Fix for FT-857/-897: S9 crashes in receiver, with or without antenna attached.

Figure 1: Two added capacitors in series with the input and output of CF1005.

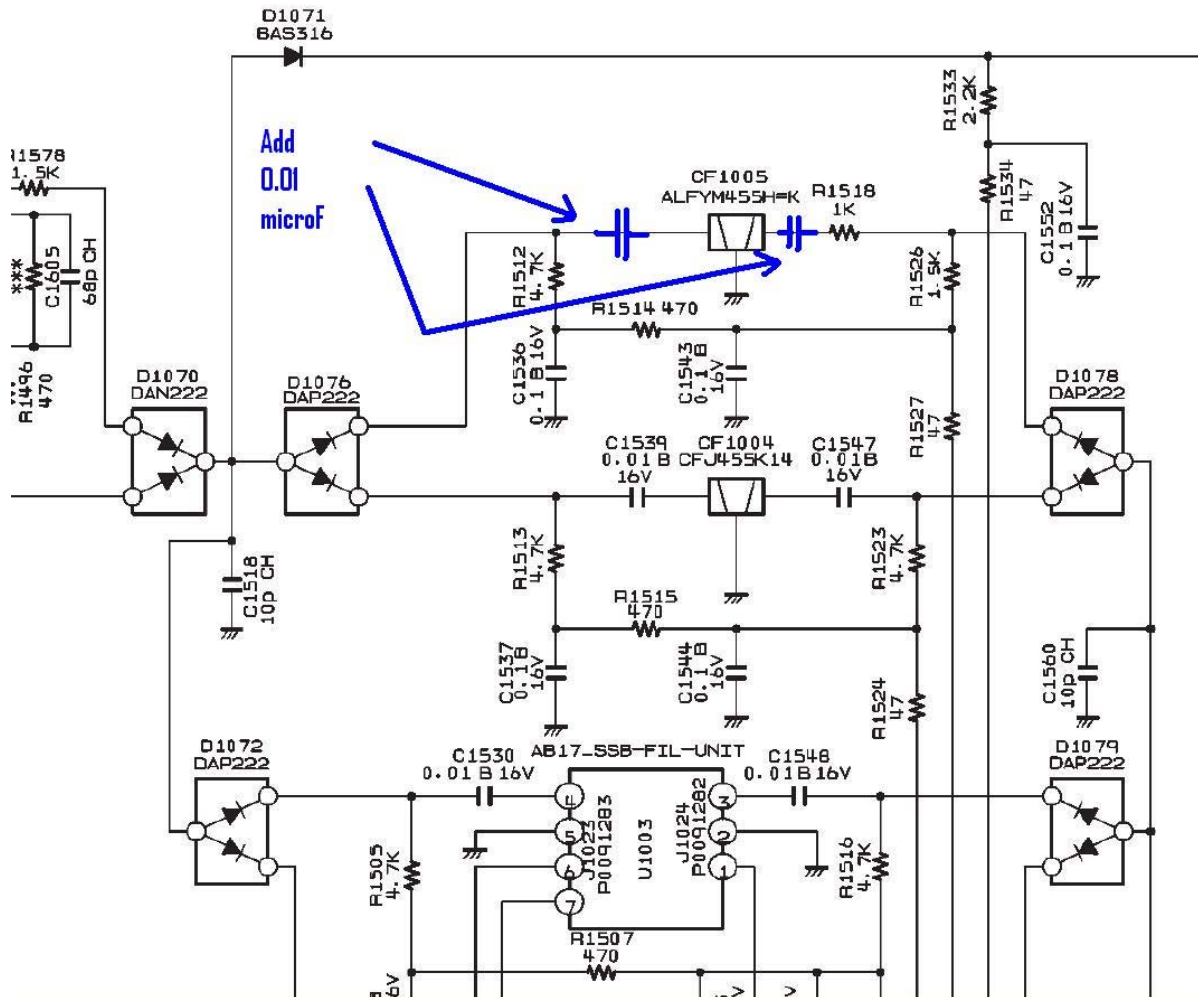
There seems to be a Yaesu design error in the FT857/897 main board. The data sheet from Toko clearly states that this ceramic filter should be AC coupled, using DC blocking capacitors. There are no such capacitors in the Yaesu schematic. The full DC diode switching voltage is applied to both the input and the output of this filter.

I had this problem in my own FT857D, purchased new in April 2008, after 23 months of operation. I have now added SMD capacitors (0.01 microF) in series with the input and output pins of CF1005. This blocks the DC voltage otherwise reaching the filter. This appears to have cured the problem, which is consistent it being a design error in the original circuit. I may have made the fix just in time, before the filter became permanently damaged.

Figure 3. An enlargement of that part of the board inside the red rectangle of Figure 2, showing the modifications.

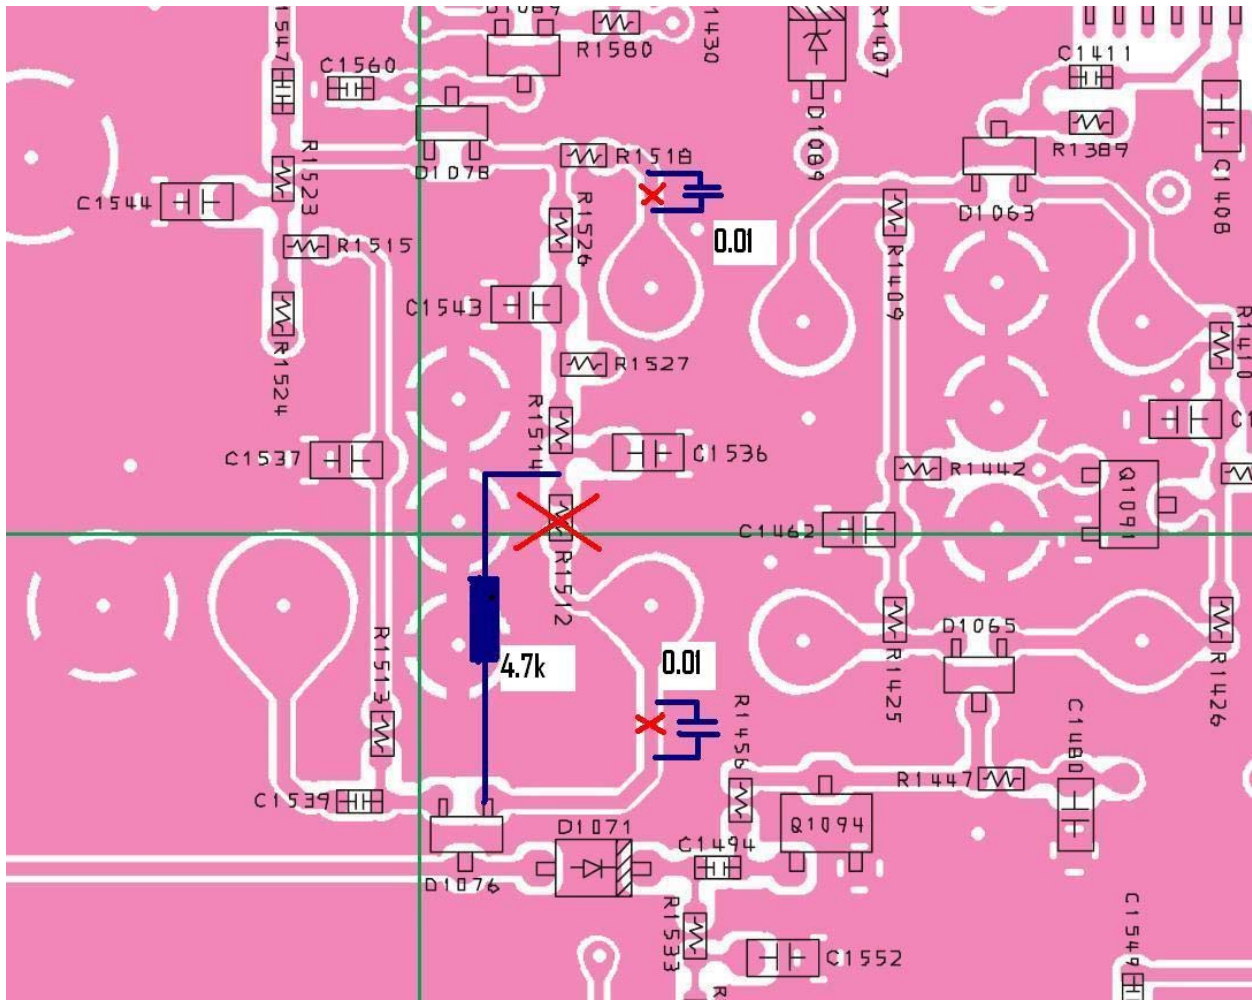
- (1) Remove the SMD resistor R1512, marked with a large red cross.
- (2) Add a 1/8-watt 4.7k resistor as shown in blue. This replaces R1512.
- (3) Cut the traces marked with the small red crosses, once below R1518, and once in the trace from D1076.
- (4) Put 0.01 microF SMD capacitors across the two cut traces, as shown in blue.
